## ***Interactive comment on “Identification of the main attribute of river flow temporal variations in the Nile Basin” by C. Onyutha and P. Willems***

**C. Onyutha and P. Willems**

Received and published: 17 February 2016

**Fig. 1.** Figure 1 General processes of a) VHM, b) NAM, and c) HBV.

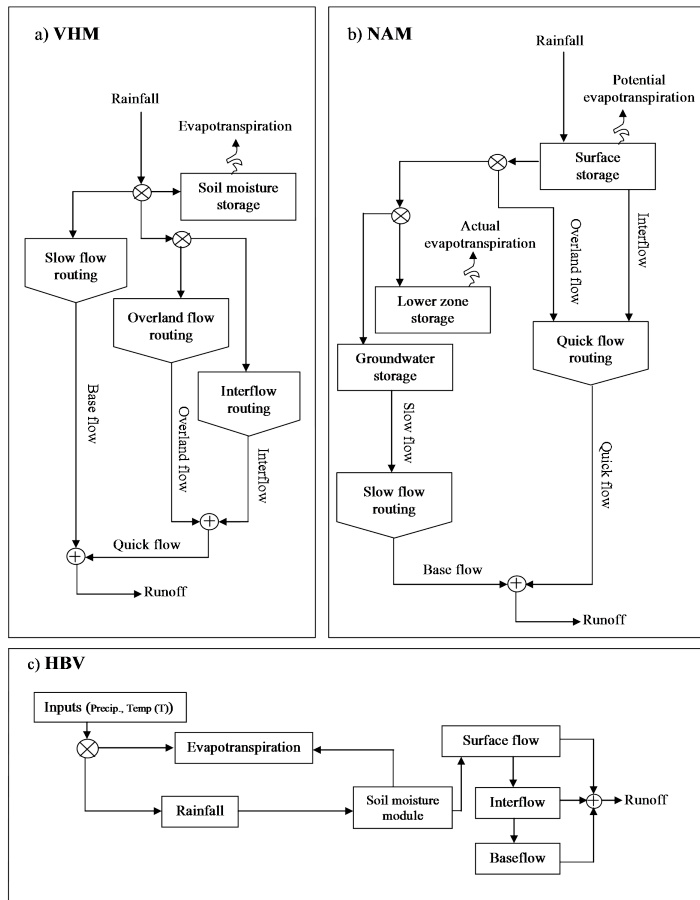
However, the approach the authors adopted is not very thorough. For example, they used three different hydrological models without giving a lot of details about these model and the simulated processes inside them.

For the details on the general processes of the rainfall-runoff models, references that the reader can consult were given in lines 4-9 (page 12174) of the Discussion Paper. However, in the revised manuscript, more text as below will be used to replace the sentence in lines 4-9 (page 12174).

VHM has been selected because its model-structure identification and calibration approach nicely fits with the objective of this research to analyze flow and catchment changes in a data-based way paper. The VHM approach starts from a generalized model structure (Figure 1a), which describes the main, lumped catchment-scale rainfall-runoff responses and processes underlying these responses. The model structure is kept parsimonious by only including processes that can be identified from the

available meteorological (model input) and river flow (model output) data. This data-based approach also allows to identify changes in catchment-wide responses and related processes. More specifically, Willems (2014) explains that in the VHM approach, the lumped macroscopic catchment responses are analyzed and main processes derived using a step-wise procedures including: 1) separation of observed discharge into overland flow, interflow and base flow, 2) extraction of nearly independent extremes in the form of peak over threshold events. These time-series processing procedures can be done using the tool provided by Willems (2009). These different sub-flow components from (1) are used to identify linear or exponential relationships in the various sub-models describing the rainfall fractions contributing to the surface storage, soil moisture storage and groundwater storage. Quick flow is obtained from a combination of the overland and interflow, which are routed separately each using a single linear reservoir. The baseflow is also routed from the groundwater storage using a linear reservoir. The total runoff is obtained as the sum of the quick flow and base flow.

For comparison reasons, the VHM results were in this study compared with the results from two other, internationally well-established models NAM and HBV whose structures are the compared in Figure 1b and Figure 1c respectively. They all consist of a number of interrelated storages for surface, soil and groundwater, relationships describing the influxes in the reservoirs, mainly depending the time-variable relative soil saturation state (derived from the soil water storage), evapotranspiration losses, and sub-flow routing by means of linear or non-linear reservoir models. Total runoff also comprises the combination of base flow and quick flow.

» SEE FIGURE 1 at the end of this document (or see the supplementary file)
